SERVICE BULLETIN

Classification: FA15-003c	Reference: NTB15-062c	Date: June 2, 2017
------------------------------	--------------------------	-----------------------

2014-2016 ROGUE; POPPING NOISE FROM FRONT SUSPENSION WHEN TURNING

This bulletin has been amended to emphasize replacement of all the parts listed in the Parts Information. Please discard previous versions of this bulletin.

Figure 1

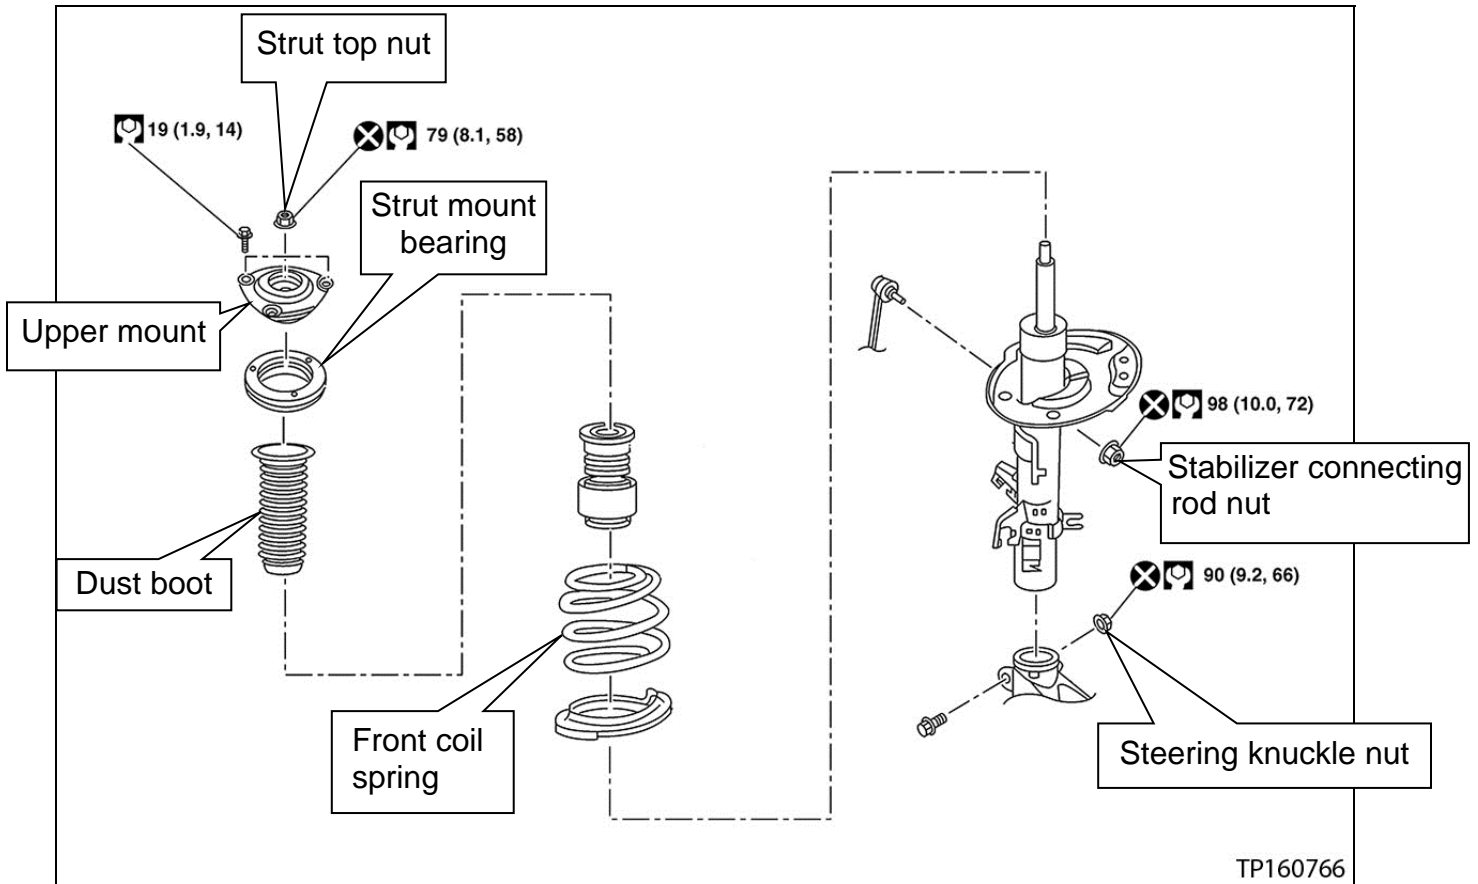
- For an effective repair, all parts called out in Figure 1 must be replaced on both front strut assemblies. These parts are also listed in the Parts Information.
- The incident noise may return if all listed parts are not replaced.

Figure 4

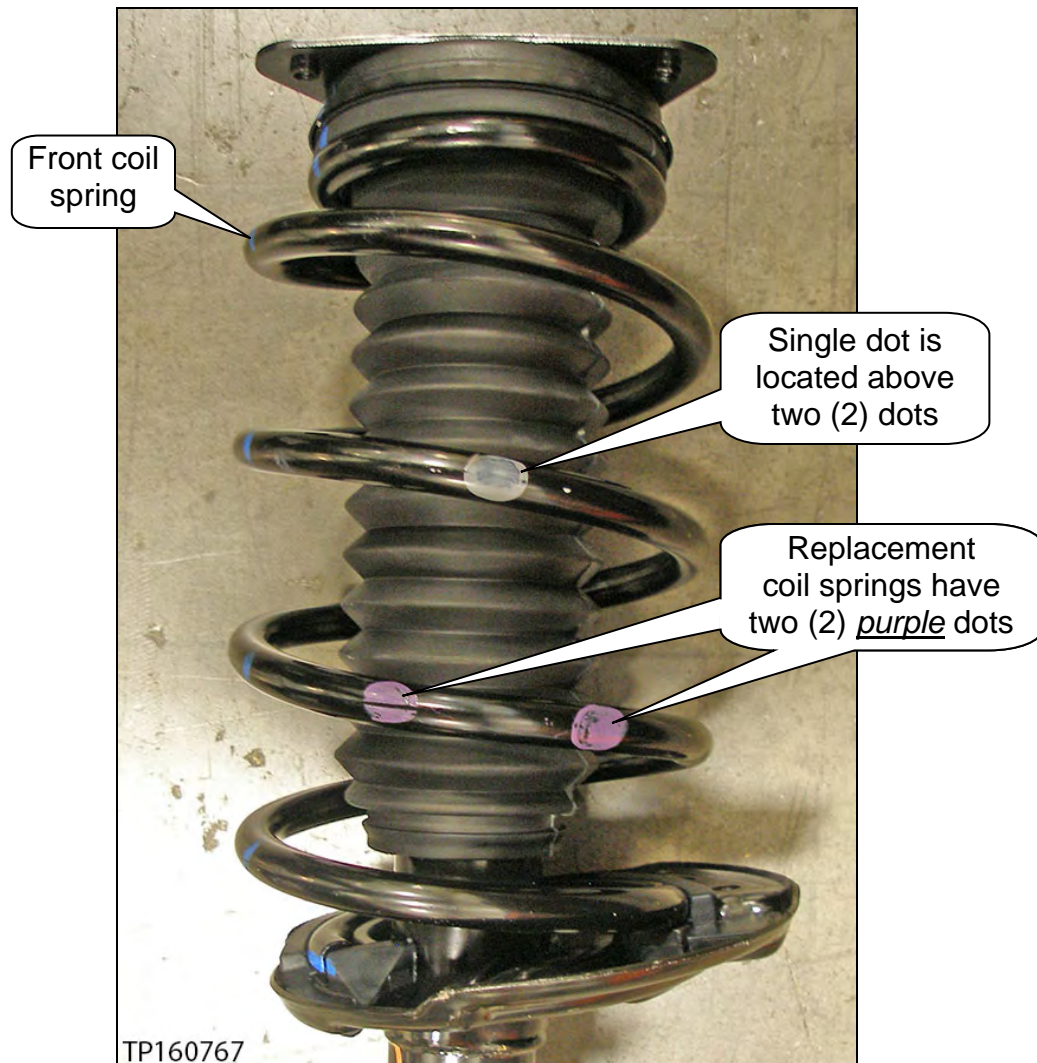
- With the coil spring installed, the single dot must be ABOVE the two dots (see Figure 4).

Figure 7

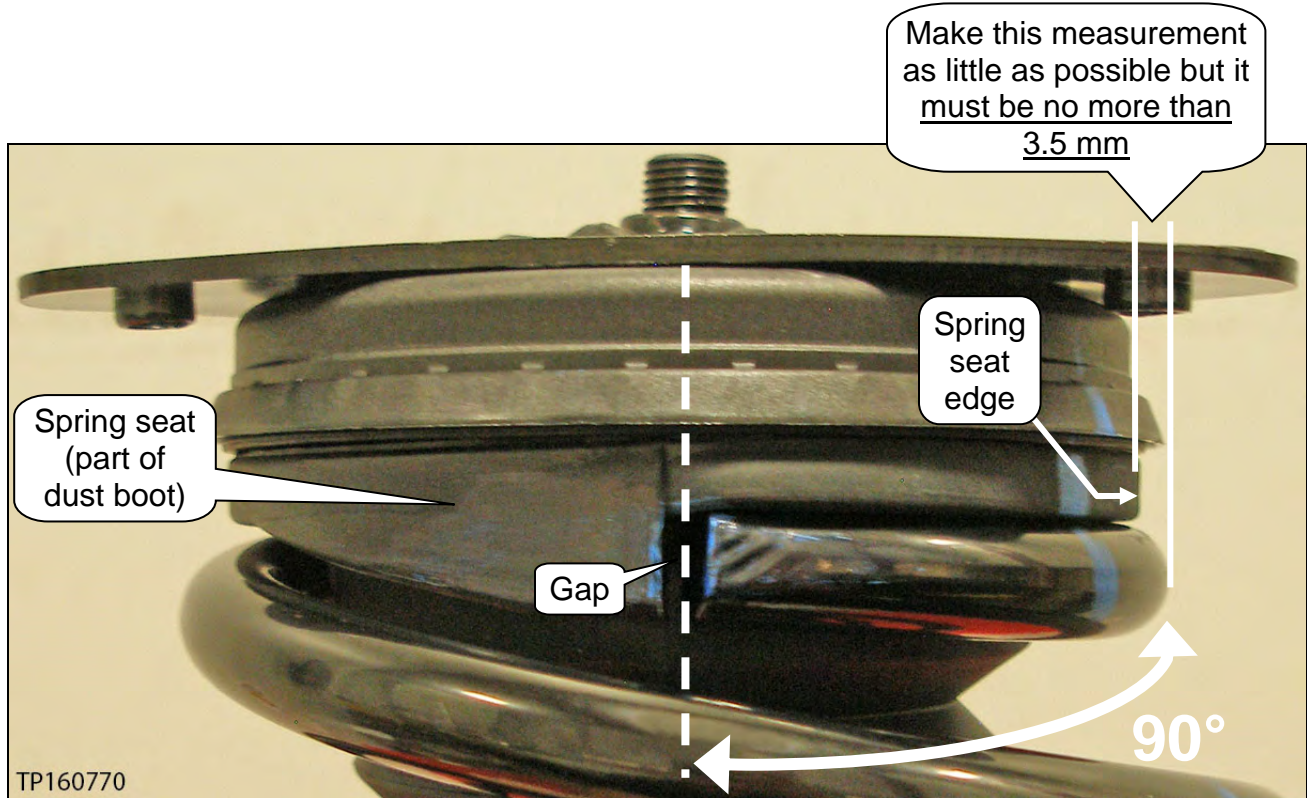
- The side edge of the upper coil spring, located 90° counter clockwise from the gap, needs to be as little as possible but it must be no more than 3.5 mm from the edge of the spring seat (see Figure 7).
- If the measurement is greater than 3.5 mm, rotate the coil spring into the spring seat (close the gap).
